<b>Permit Number:</b> C-1981-019 <b>Mine Name:</b> Colowyo Coal Mine <b>Operator:</b> Colowyo Coal Company L.P. <b>Operator Address:</b> Mr Tony Tennyson 5731 State Highway 13 Meeker, CO 81641	<b>County:</b> Moffat, Rio Blanco <b>Operation Type:</b> Surface <b>Permit Status:</b> Active <b>Ownership:</b> Private
	<b>Operator Representative Present:</b>  Tony Tennyson
<b>Operator Representative Signature: (Field Issuance Only)</b>

<b>Inspection Start Date:</b> October 30, 2024 <b>Inspection Start Time:</b> 08:00 <b>Inspection End Date:</b> October 30, 2024 <b>Inspection End Time:</b> 13:00		<b>Inspection Type:</b> Coal Partial Inspection <b>Inspection Reason:</b> Surety Release Requested <b>Weather:</b> Cloudy	
<b>Joint Inspection Agency:</b>  OSM		<b>Joint Inspection Contacts:</b>  Jim Stark	
<b>Post Inspection Agency:</b>  OSM		<b>Post Inspection Contacts:</b>  Jim Stark	
<b>Inspector(s):</b>  Hunter Ridley	<b>Inspector's Signature:</b>  <i>Hunter Ridley</i>		<b>Signature Date:</b>  November 12, 2024

As part of the Colowyo SL-23 application, a statistical vegetation sampling analysis is not required, as revegetation standards outlined in Rule 4.15.8 do not apply to riprap lined,

*Photo 10: View of the meandering channel area, taken at ~Station 40+00, the riprap channel edge is visible on the left.*

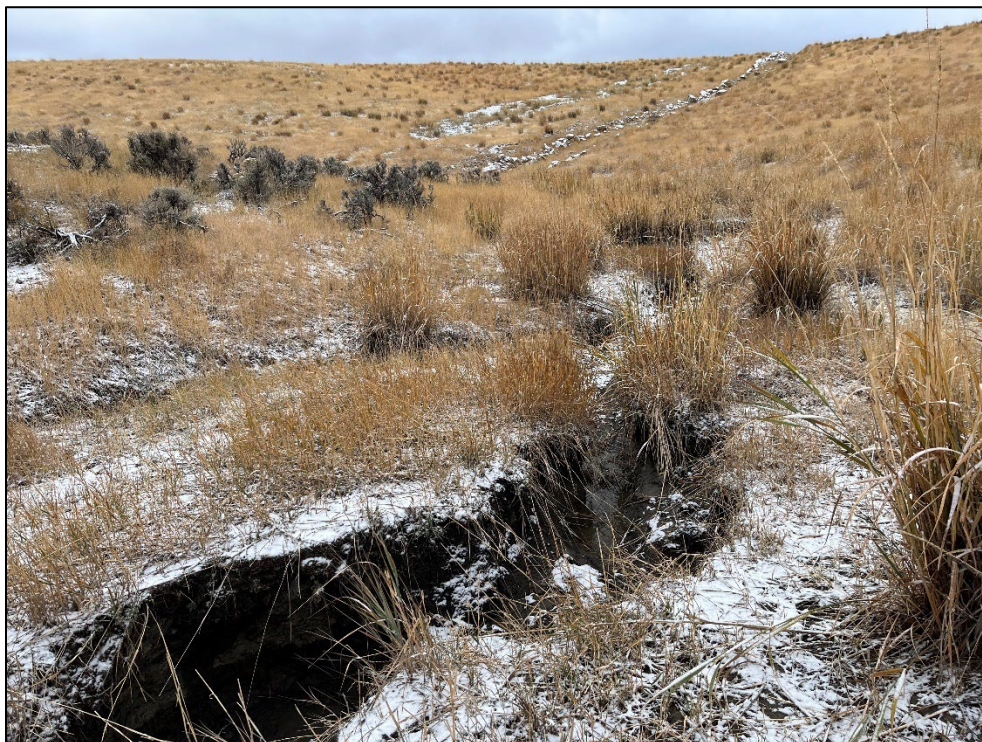
Streeter Ditch was walked in its entirety, from Streeter Pond to Lower Section 3 Pond, beginning from an access road in the mid-section of the ditch. Data was collected at various points along the ditch where accessible. In total, nine points of data (represented below in Table 1) were collected. Measurements were taken at each point to determine elevation, channel width, channel depth, and channel material to be checked against the SEDCAD design and as-built profiles for the ditch. In depth analysis of these data points will be provided as part of the Division’s Proposed Decisions and Findings of Compliance Document for SL-23. During visual inspection of the ditch, no erosional issues were noted, and no areas were identified that would suggest stormwater would flow outside of the approved channel area. Rip rap was in place and stable along the channel areas approved for such design (Stations 0+00 to 45+00). From Stations 45+00 to 68+41, the channel shifts into a vegetated channel. Around Station 40+00, the channel widens and has taken on a braided effect with smaller meandering channels which have established within the larger channel itself (Figure 2). These meandering channels, however, are not very deep or wide, have been at a stable size for many years, and are well within the width of the constructed ditch channel (Photos 9 and 10). The same pattern of steady state meander repeats from approximately Station 62+00 to 67+00.
